Clover Creek Solar Project LLC d/b/a New Frontiers Solar Park
Responses to Siting Board Staff's First Request for Information
Case No. 2024-00253

Request No. 1:

**Clover Creek Solar Park
Oil & Gas Well Map**

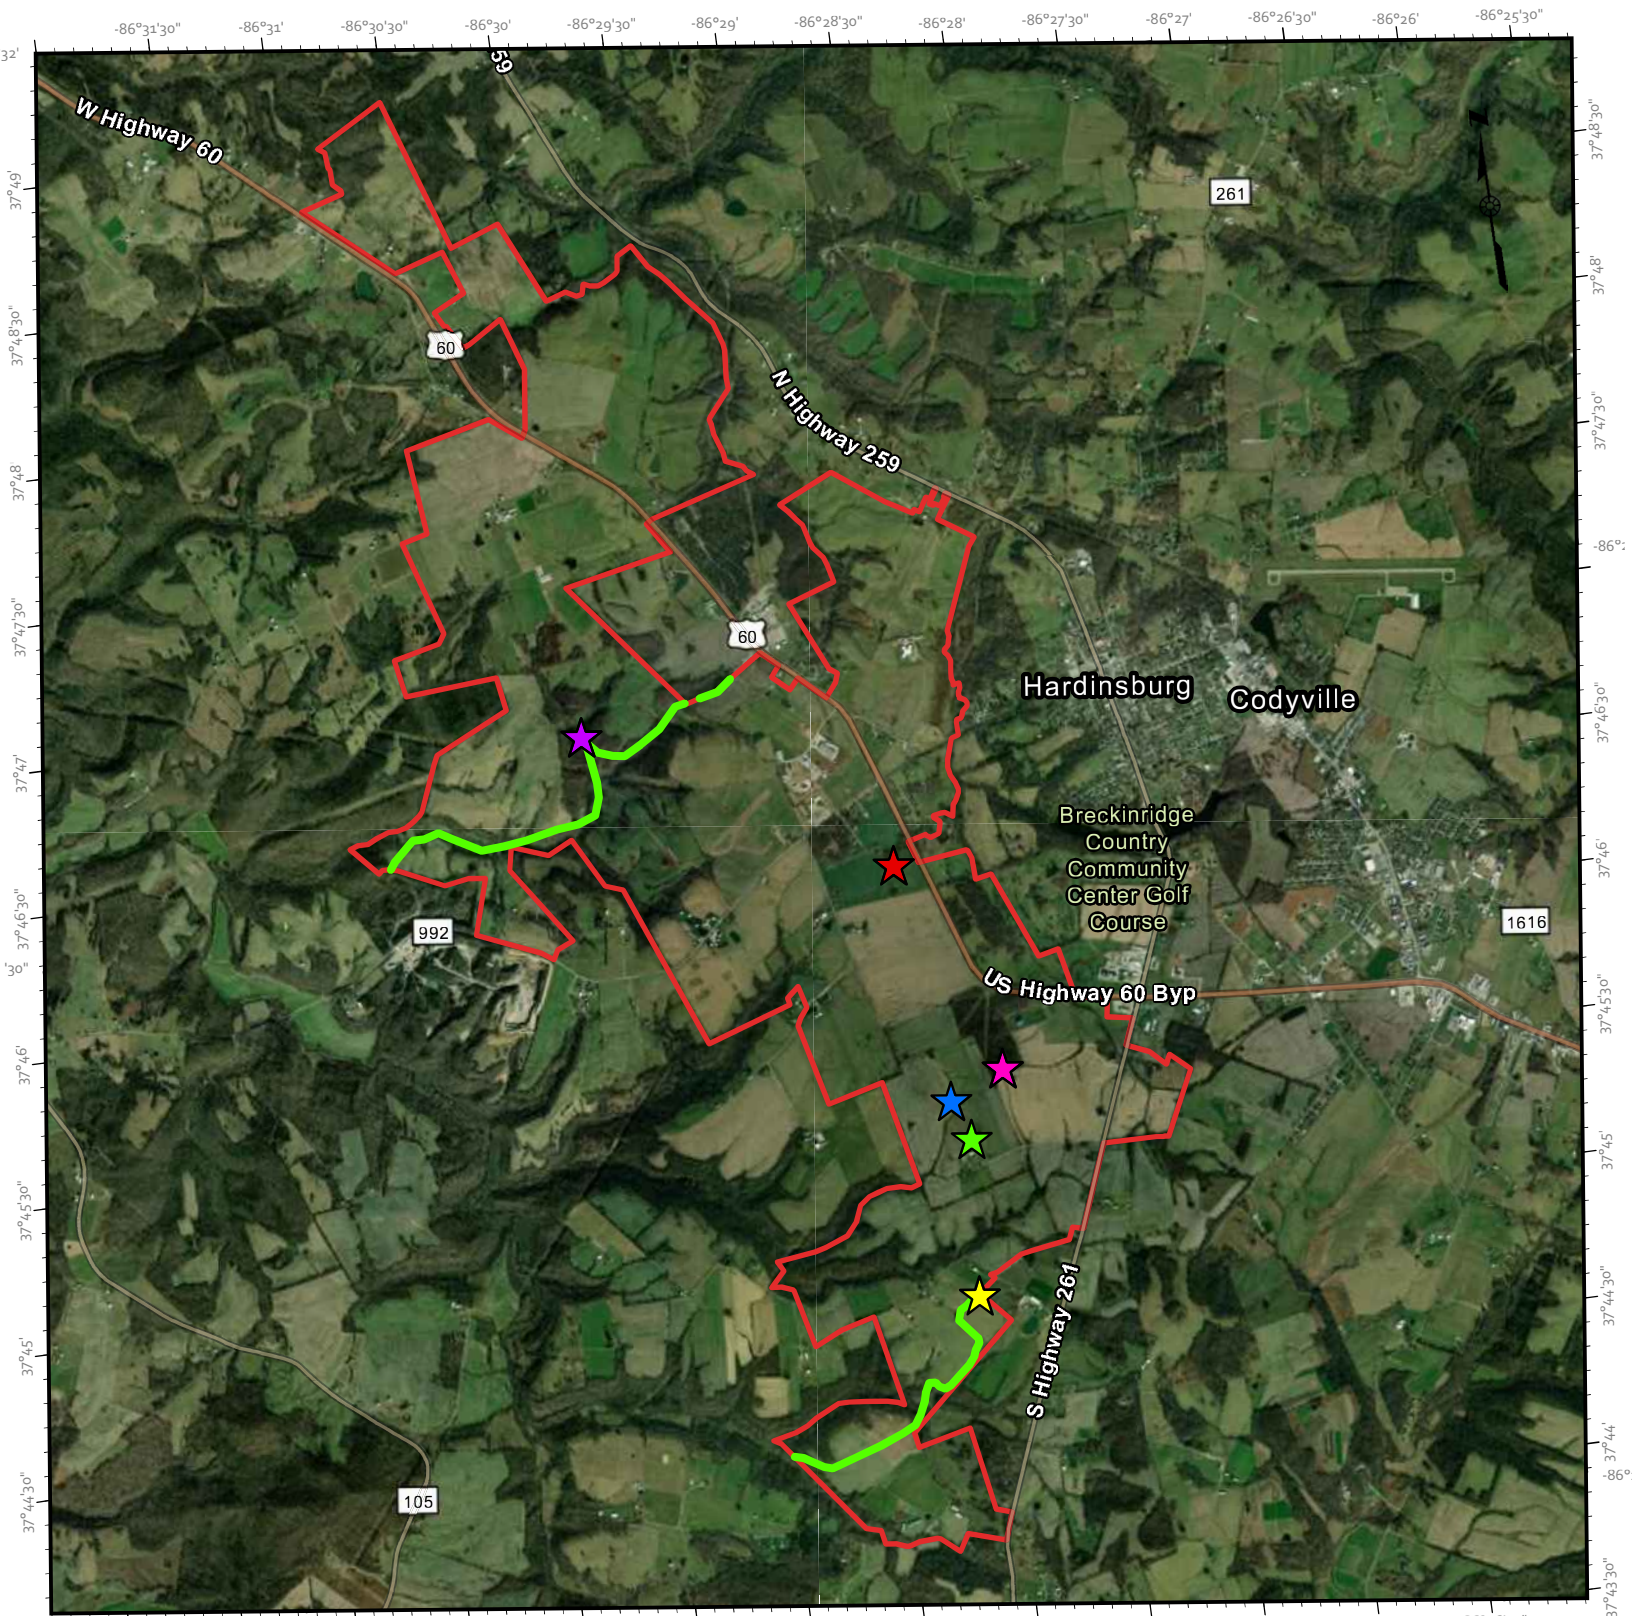
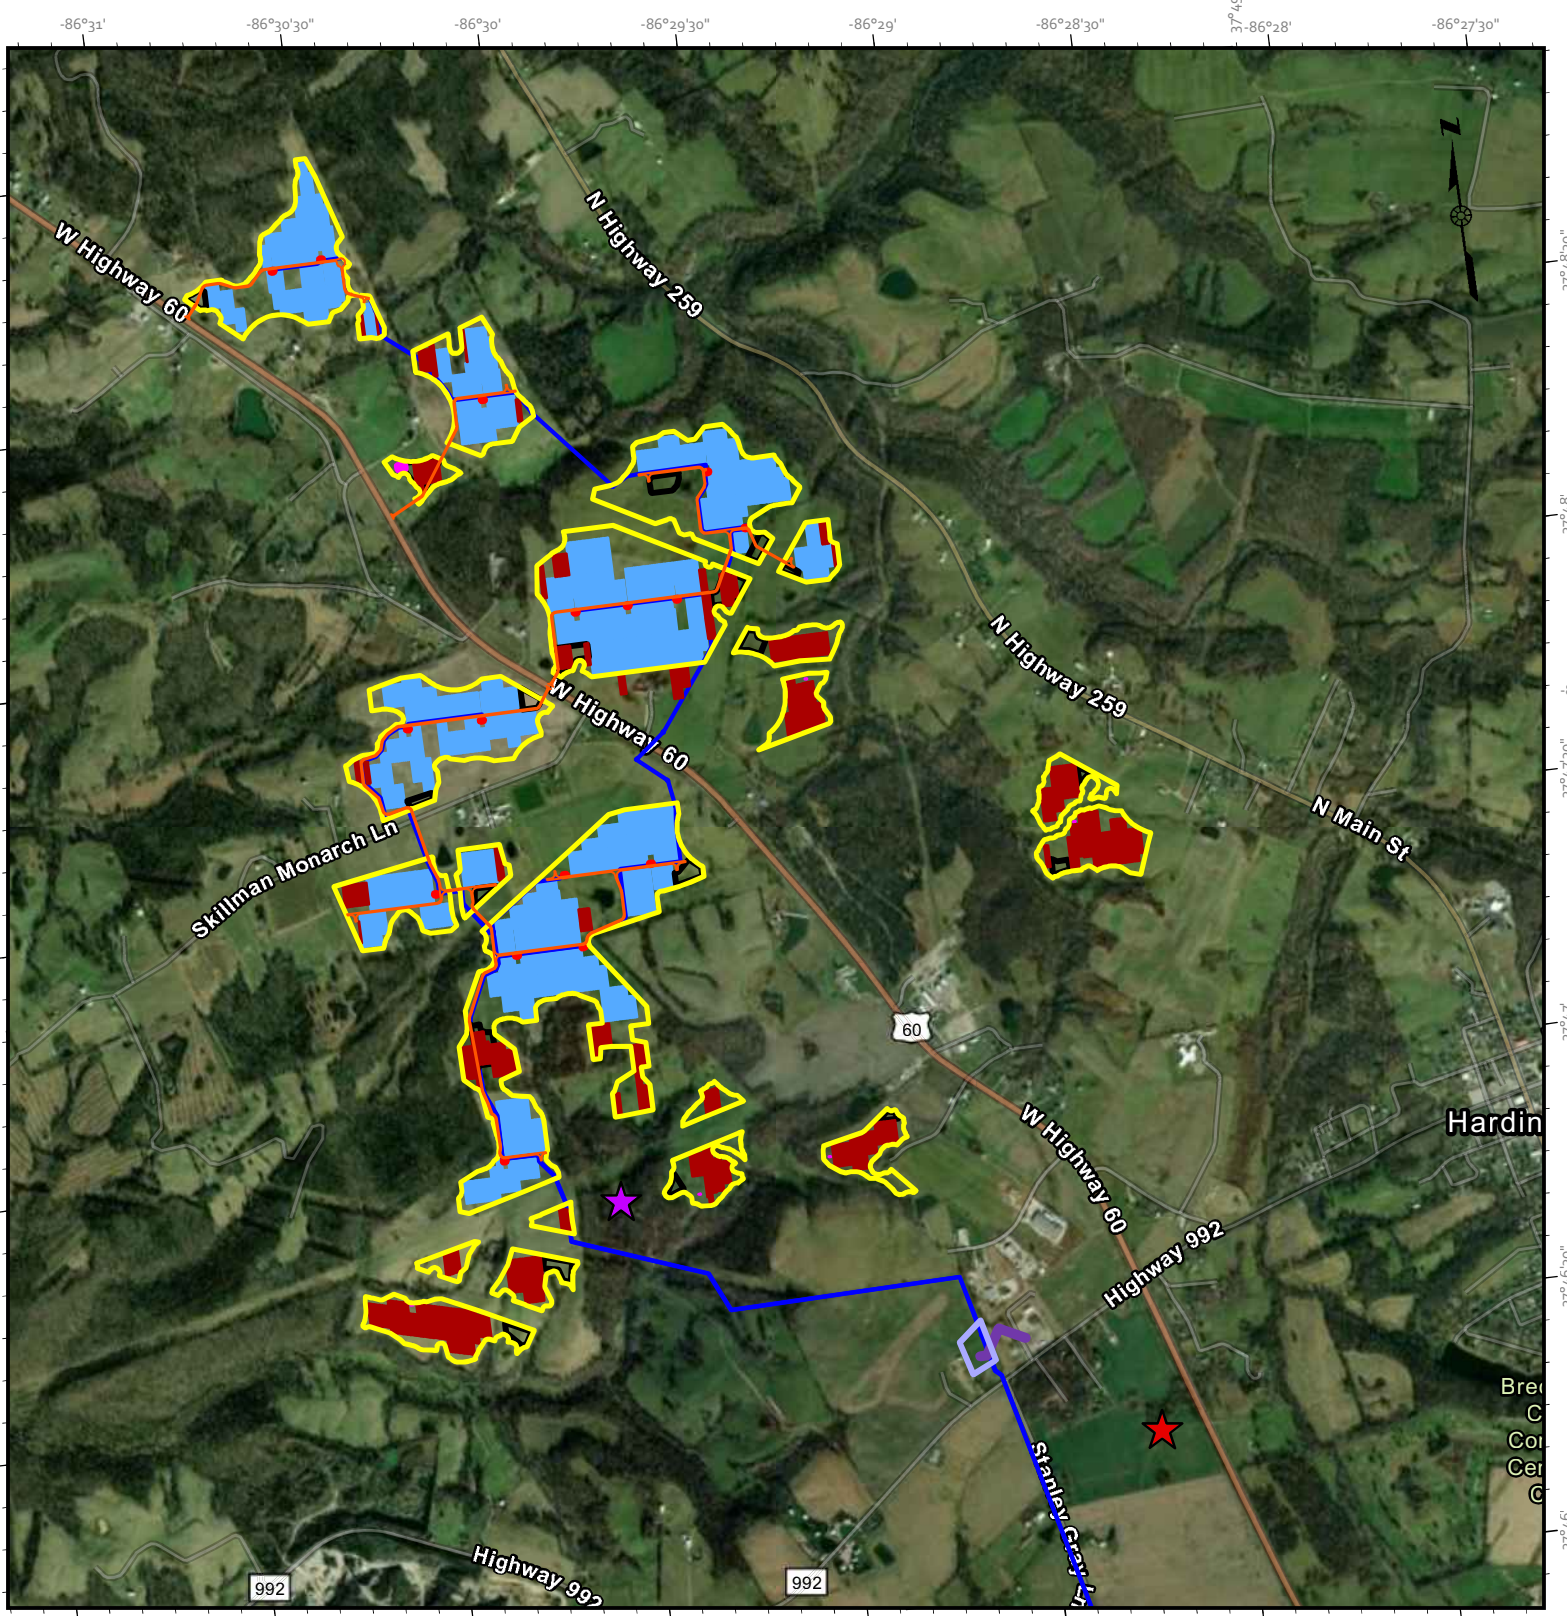
- a. Provide a map with all active and inactive oil or gas wells on the proposed site. Also include any gas- gathering pipelines associated with the wells.
- b. Determine and confirm whether any of these wells are currently permitted and active.
- c. Confirm whether the existence of oil and gas wells and pipelines will require adjustments to the proposed location of solar panels.
